# UNITED STATES PATENT AND TRADEMARK OFFICE

10/597,809

<b>Office Action Summary</b>	<b>Application No.</b> 10/597,809	<b>Applicant(s)</b> FISHER ET AL.	
	<b>Examiner</b> JOHN C. INGHAM	<b>Art Unit</b> 2814

## DETAILED ACTION

**FIG. 7**

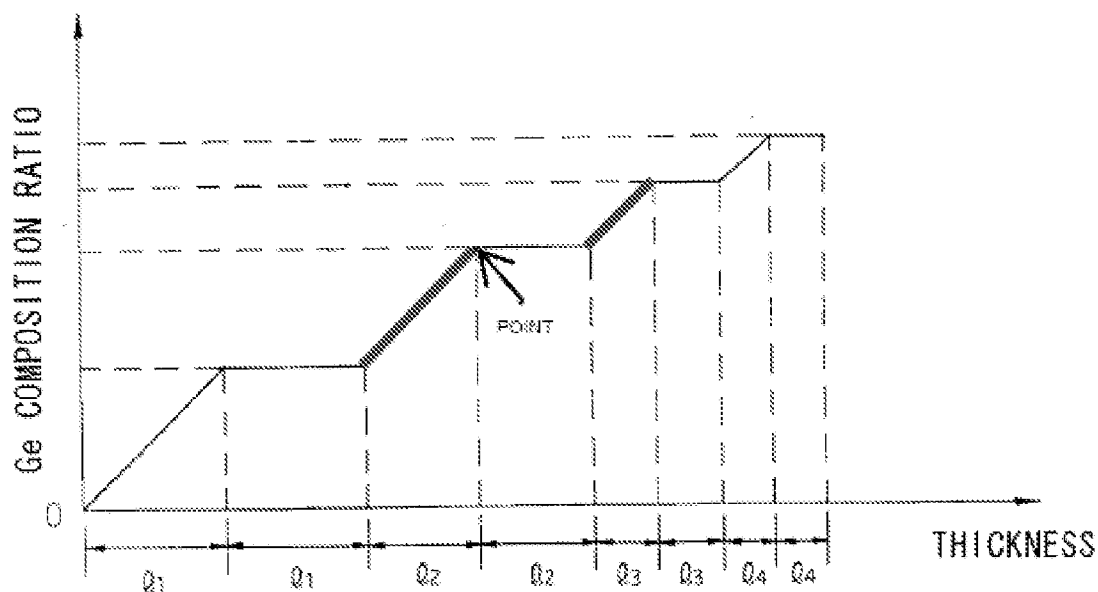
3. Regarding claims **1 and 13**, Mizushima discloses in Fig 7 a semiconductor device and a method of manufacture comprising a substrate (Fig 1 item 1) of a first semiconductor material (Si) and a compound layer (Fig 1 item 2) of said first semiconductor material and a second semiconductor material (SiGe) disposed on the substrate, the ratio of the first material to the second material of the compound layer being decreased (q3, Si decreases) away from the substrate towards the upper surface of the compound layer, wherein the rate of decrease of the ratio varies linearly on opposite sides of an intermediate point disposed within the layer (2) at which the rate varies (rate of Si decrease in q2 is different than rate of Si decrease in q3).

4. Regarding claims **2 and 14**, Mizushima discloses in Fig 7 the device of claims 1 and 13, in which the rate of decrease of the ratio increases away from the substrate towards the surface of the compound layer (rate of q2 is less than rate of q3).

5. Regarding claim **7**, Mizushima discloses in Fig 7 the device of claim 1, in which a final layer (Fig 2 item 4) comprising said first material (Si) is deposited on the surface of the compound layer (2).

14. Regarding the argument on page 5 that the decrease of the ratio does not vary linearly on opposite sides of a point. The claim language does not preclude a constant value on one side of the point, since a constant value is a linear value. Moreover, if a point is picked between the sloped section q2 and the constant section q2 in Fig 7 of Mizushima, reproduced below, then the sloped section of q2 and the sloped section of q3 are on opposite sides of the point, and clearly vary from each other (relevant

sections of drawing with thicker lines) as claimed. However, the sloped section of q2 and the constant section of q2 also vary, and both are linear (e.g. the slope of each is a constant, linear value). Therefore all of the claimed limitations are met: wherein the ratio of the compound layer decreases from the substrate to the upper surface, wherein the rate of decrease varies (i.e. is different) linearly opposite sides of an intermediate point.
